**SOUTHEAST ATLANTA LIBRARY
ADDENDUM #2
SEPTEMBER 25, 2014**

Addendum #2 Requests For Information

Project [L006] - **View Date** 9/9/2014
Southeast Library

NEW SOUTHEAST ATLANTA
BRANCH LIBRARY
 1463 SOUTH PRYOR ROAD, ATLANTA /
 FULTON COUNTY GEORGIA 30314

Drawing No. C3.10 **Detail No.**
CSI Code **Reference No.**

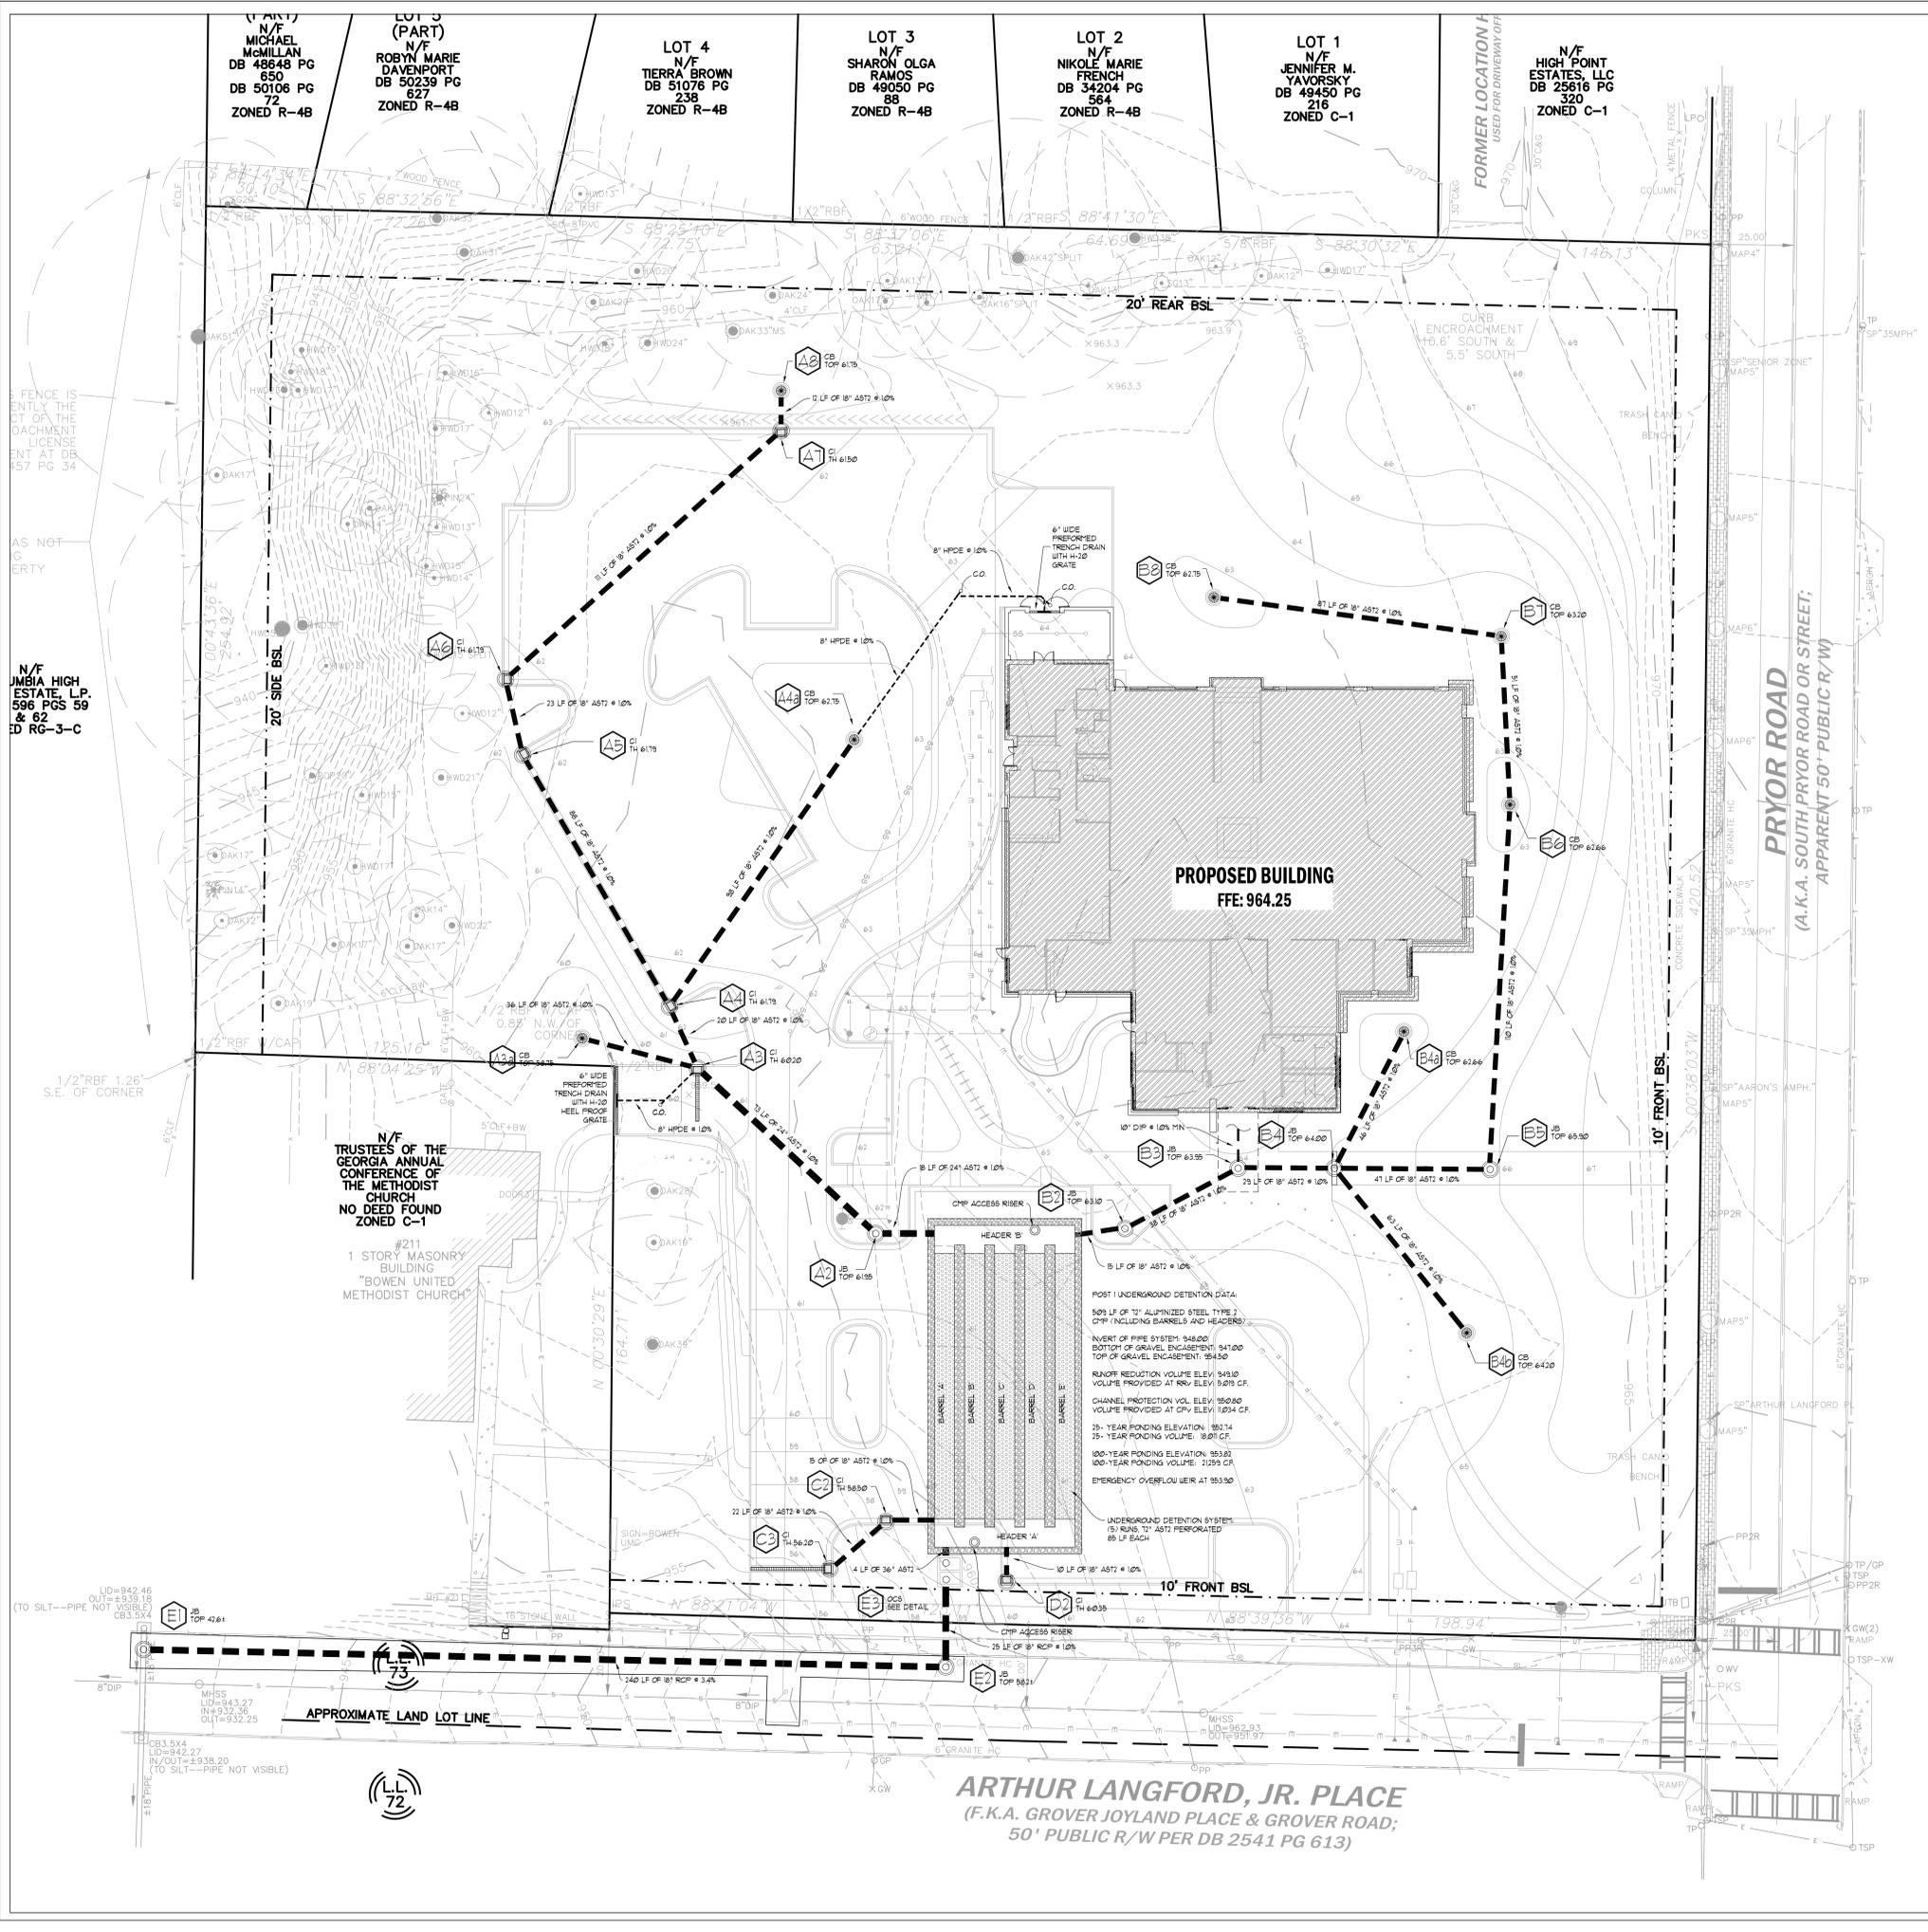
Plumbing Drainage Floor Plan shows locations for downspouts leading from roof drains on the sides of the buildings. Detail 1/C6.10 shows downspout/rainleader cleanout detail but Site Drainage Plan C3.10 does not show locations for piping tie-in to underground storm. Please provide tie-in locations and piping plan.

Response Only one internal drain exits the building, the 10" line to the south. Other roof drains shown on plumbing drawings are overflow from roof that exit via lamb's tongue above grade.
Response By Alan Wieczynski- Breedlove Land Planning
Responded Refer to plumbing and architectural drawings for details.
9.11.14

3 HEAVY DUTY CONCRETE PAVING
NOT TO SCALE

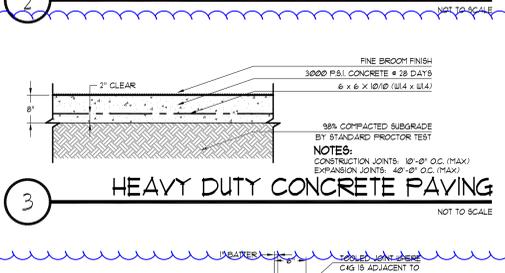
Sheet C2.00 notes that slab for mechnacal yard should be heavy duty pavement (Ref. Detail 3/C6.00). Finish schedule on A1.22 states that the mechanical yard should be gravel. Please confirm mechanical yard will recieve heavy duty pavement.

Response Mech yard will be heavy duty concrete paving. Refer to C200, C300 and C600 for details.
